**DEPARTMENT OF TRANSPORTATION
STATE OF GEORGIA**

SUBJECT **APPROVED CONCEPT REPORT**

**DEPARTMENT OF TRANSPORTATION
STATE OF GEORGIA
LIMITED SCOPE PROJECT CONCEPT REPORT**

Review of Concept Layouts:

PI 0011672
CONCEPT LAYOUT
OCTOBER 2013
INT #1 SR 53 @ I-85 NB

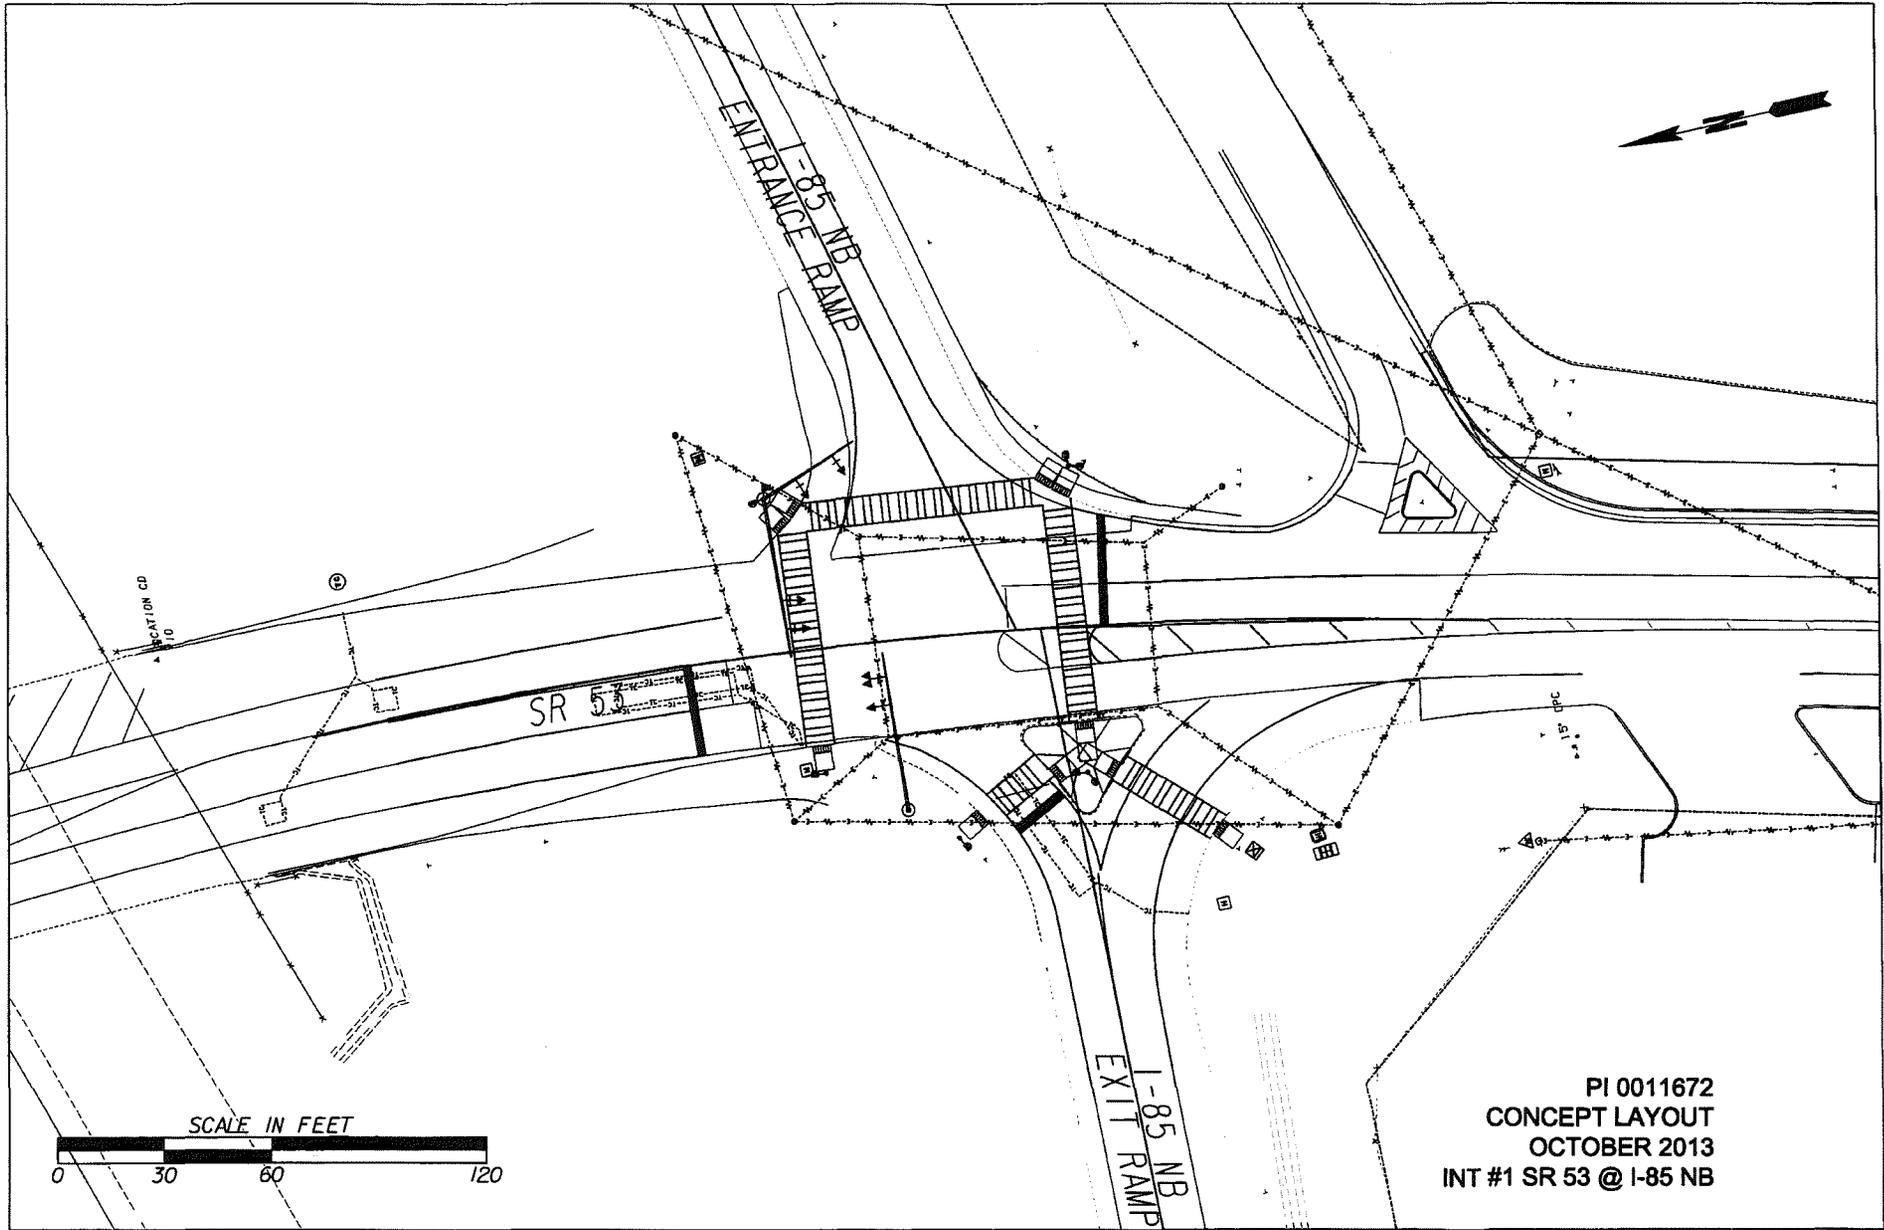
Intersection #1

- The strain pole in the island should be moved to the shoulder
- The guardrail adjacent to the I-85 NB Entrance Ramp can be shifted back to allow for a pedestrian landing crossing to this corner. This may require a cut through on the existing island of the Exit Ramp. Crosswalks will be added to this corner

- Check the turning movement of I-85 NB Exit Ramp to SR 53 northbound and adjust the stop bars as necessary.

PI 0011672
CONCEPT LAYOUT
OCTOBER 2013
INT #2 SR 53 @ I-85 SB

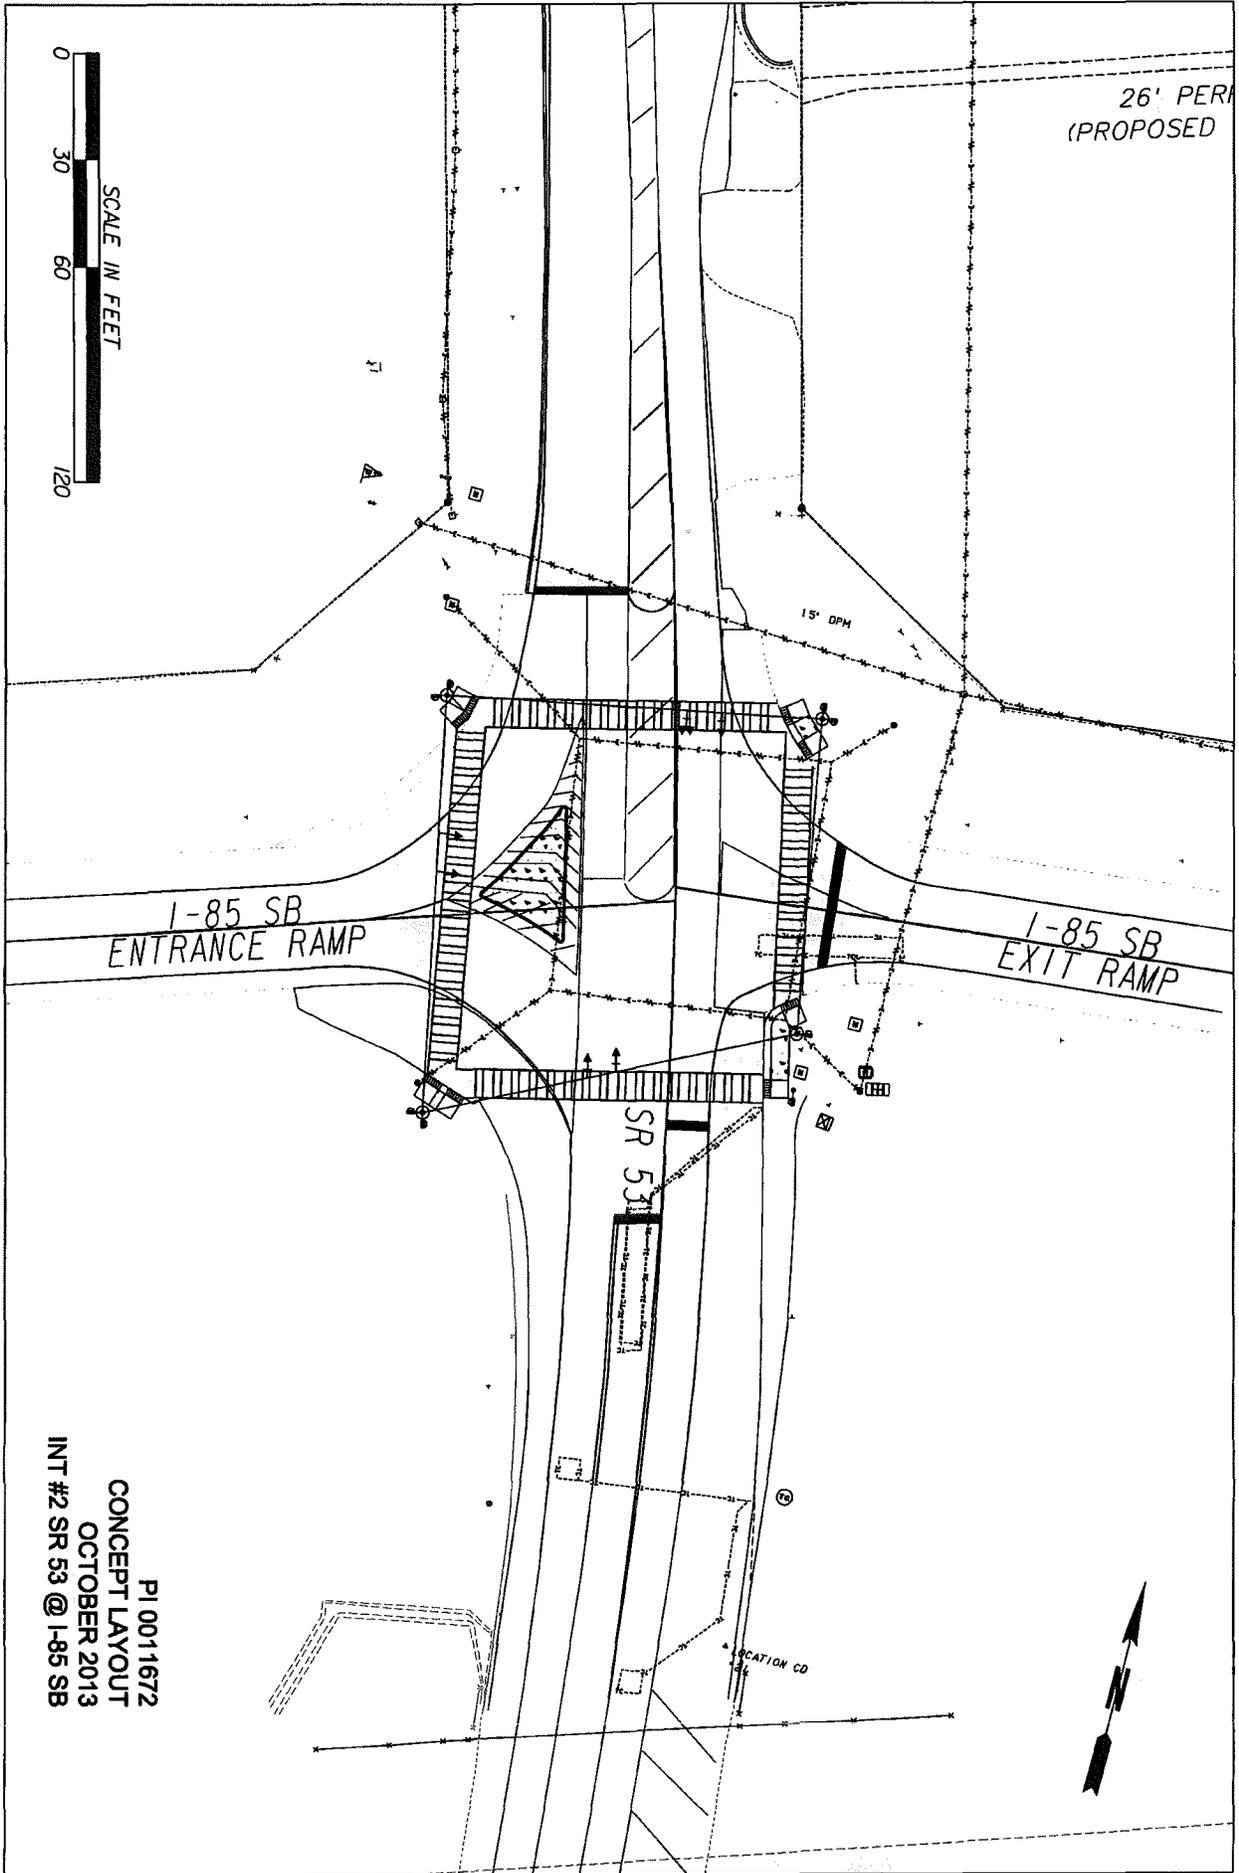
Intersection #2

- Change the striped island on the I-85 SB Entrance Ramp to a raised island
- Extend the SR 53 SB stop bar all the way across and move it back, this will allow the crosswalk to be adjusted to a more perpendicular crossing.
- Once plans for the project to the north of this intersection are available they will be incorporated into the design
- This will likely need to be converted to a span wire configuration
- A signal head may need to be added for the right turning exit ramp traffic

PI 0011672
CONCEPT LAYOUT
OCTOBER 2013
INT #3 SR 98 @ I-85 NB

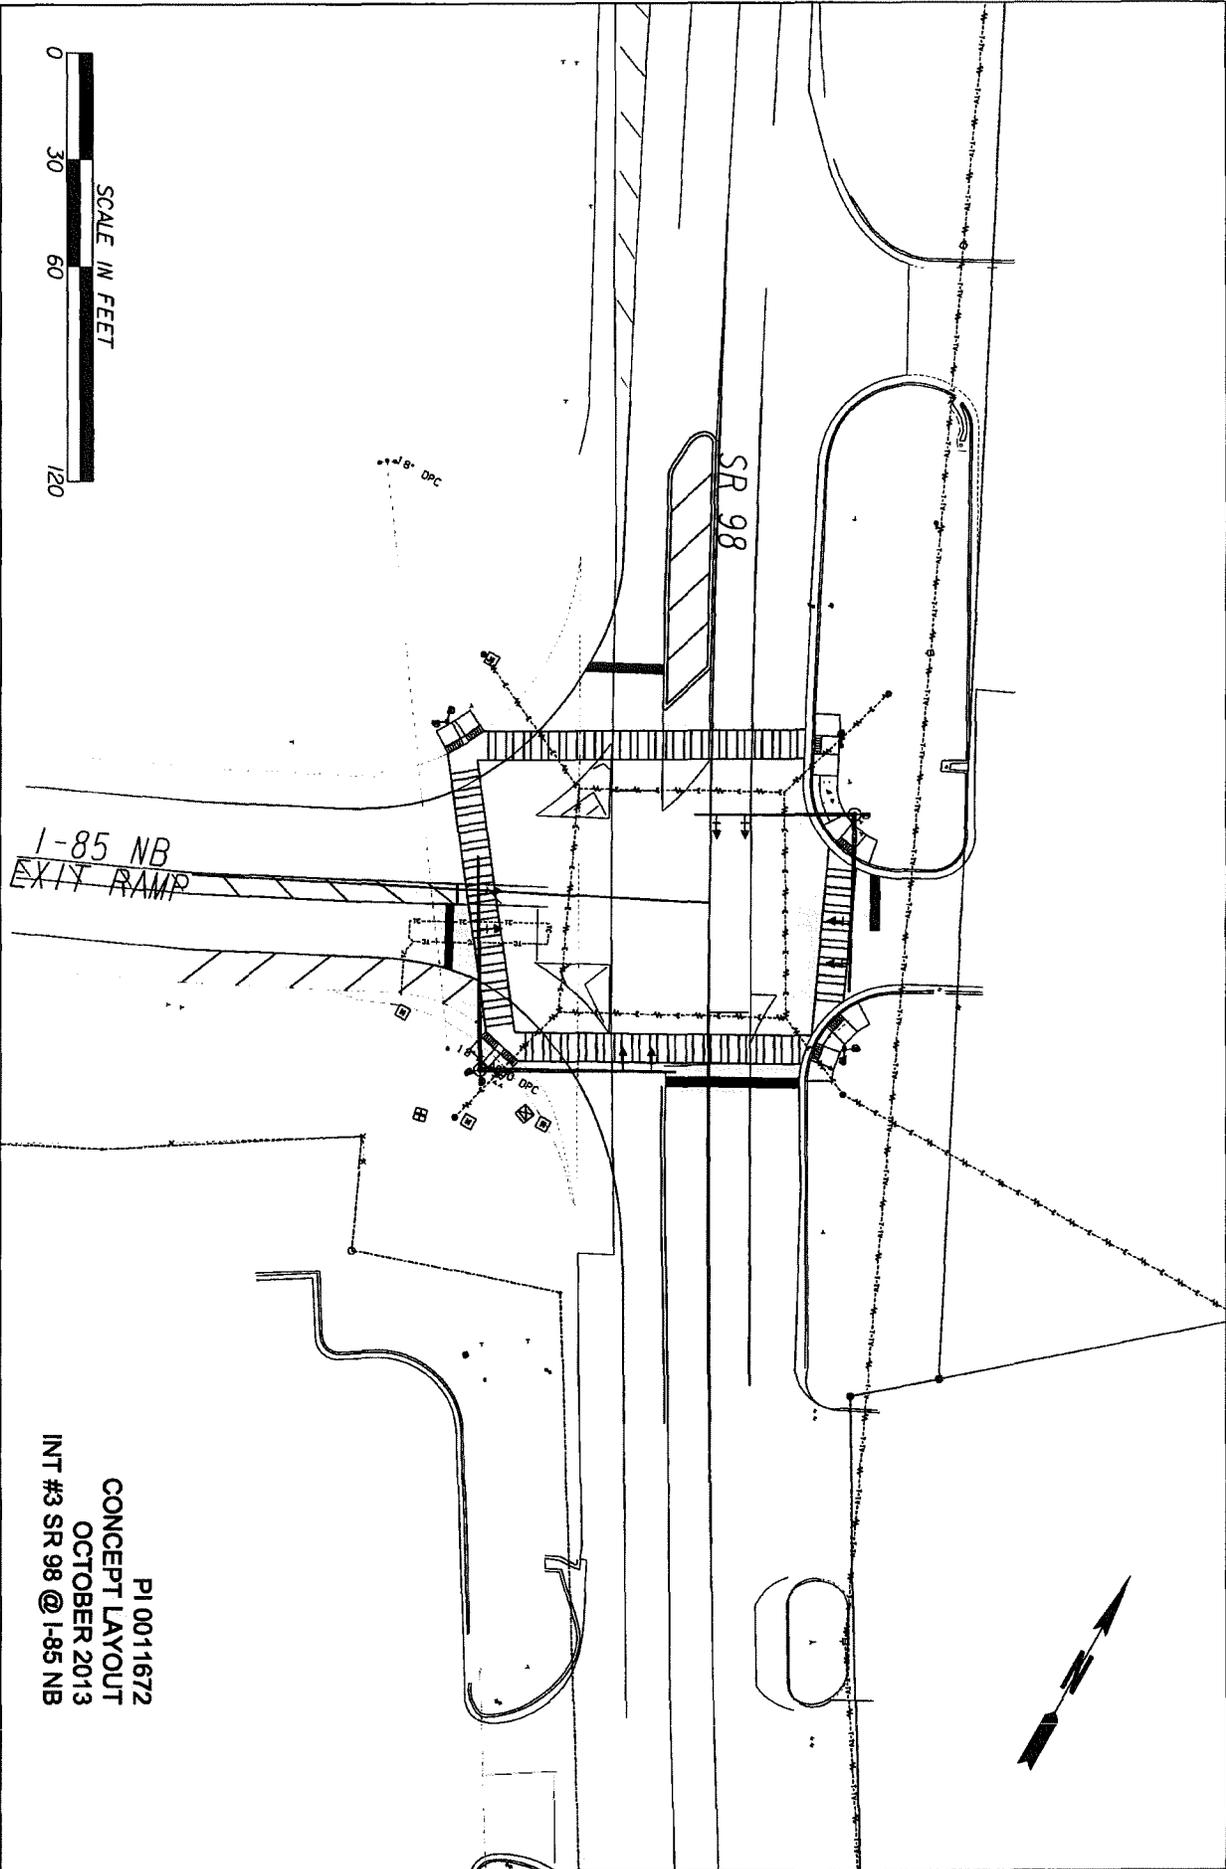
14. **Intersection Control additions or modifications that require permitting**
At Int #3 there is gas station driveway across from the end of the interstate ramps. Currently the ramps are signalized, but the gas station driveway is not. It is proposed to include the driveway into the signal.

Intersection #3

- Include a crosswalk to the southern corner. Make this a perpendicular crossing which will pull the stop bars back
- Make the crosswalk across the north side of SR 98 perpendicular, which will pull back the stop bars and hatching
- Extend all stop bars across lanes

PI 0011672
CONCEPT LAYOUT
OCTOBER 2013
INT #4 SR 11 @ WAYNE POULTRY RD

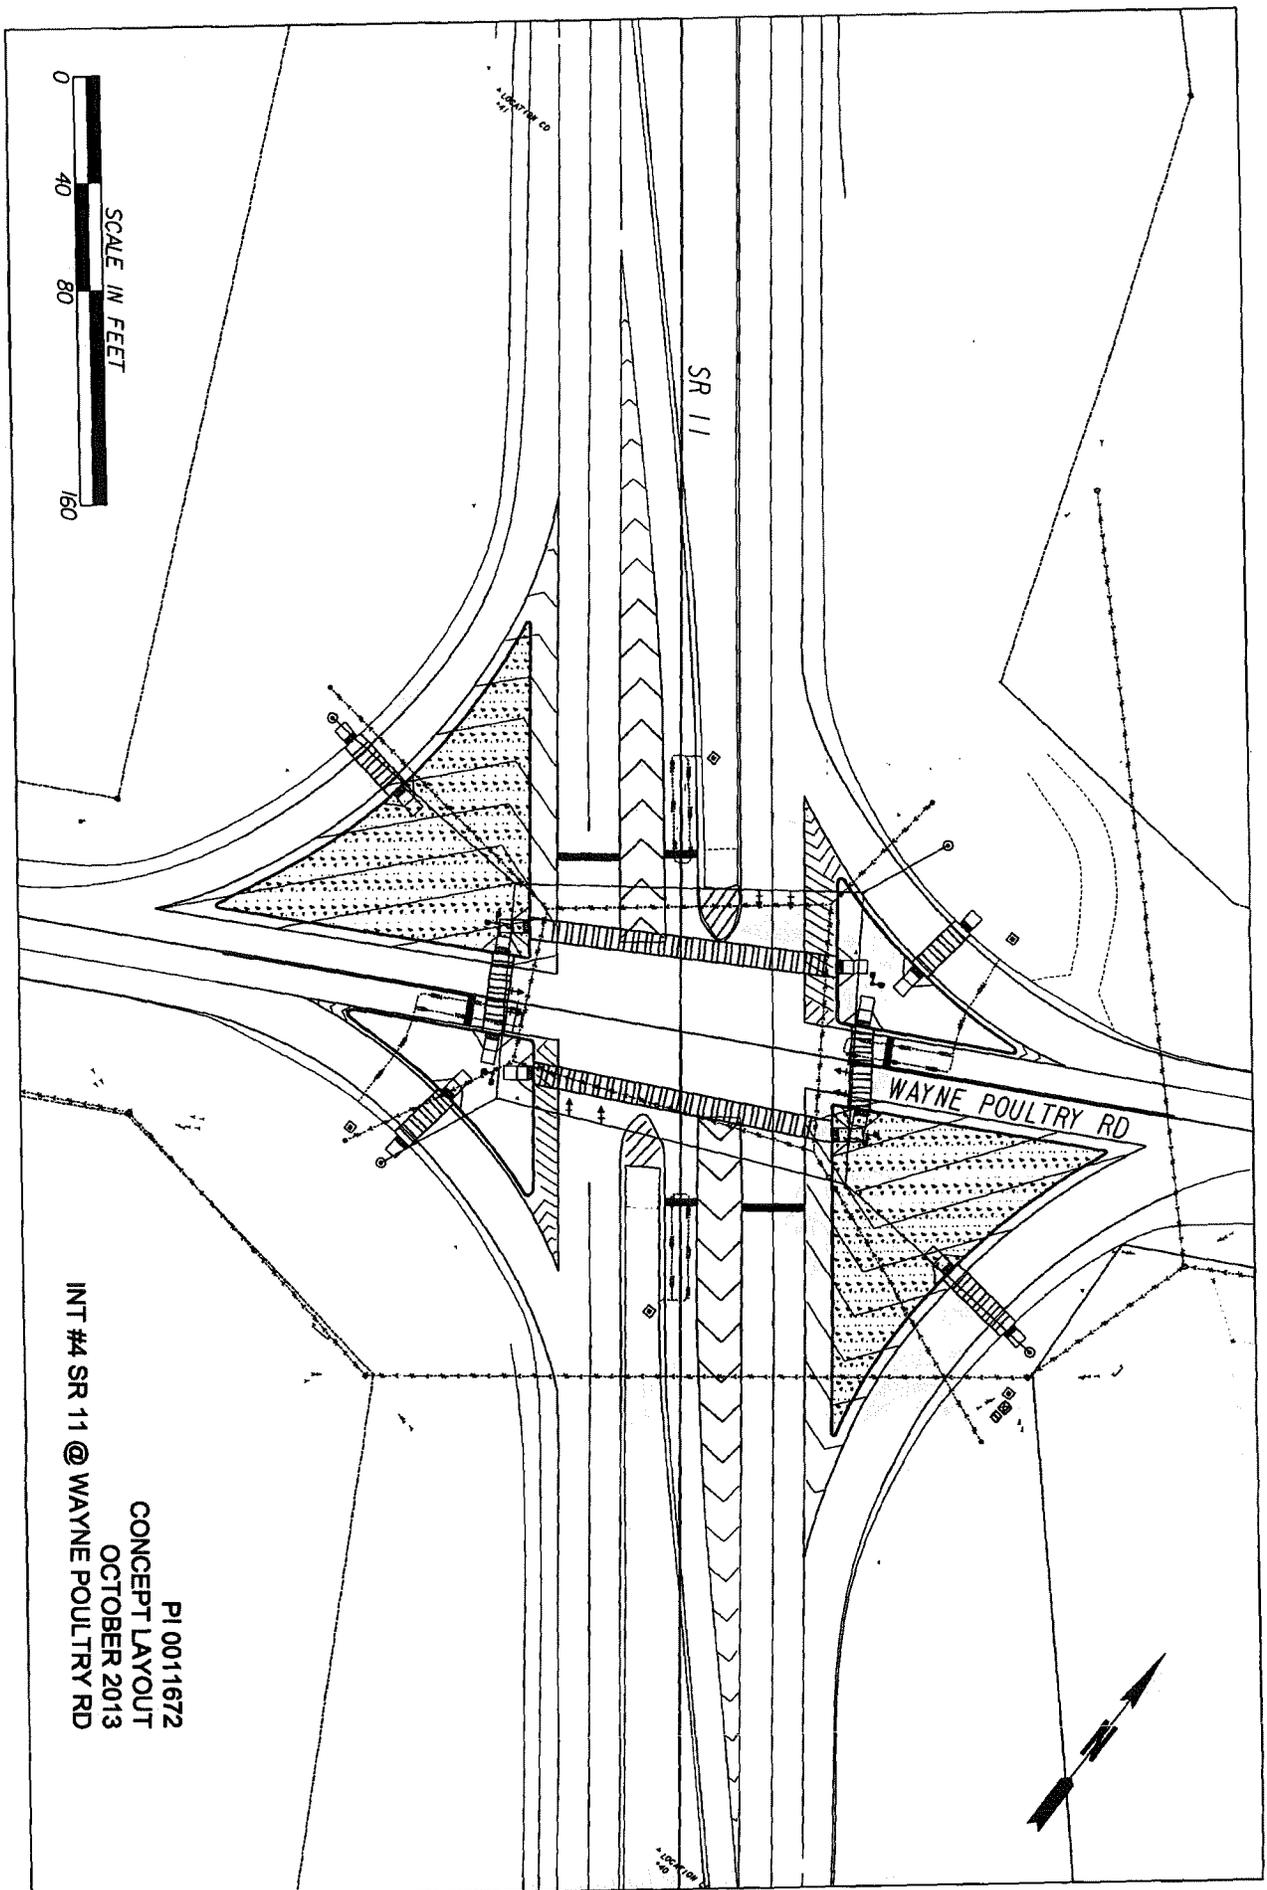
Intersection #4

- This will need to be converted to a span wire configuration to allow for future left turn signal heads.
- The District will check with Maintenance to see if the proposed islands are preferred to be grass or concrete
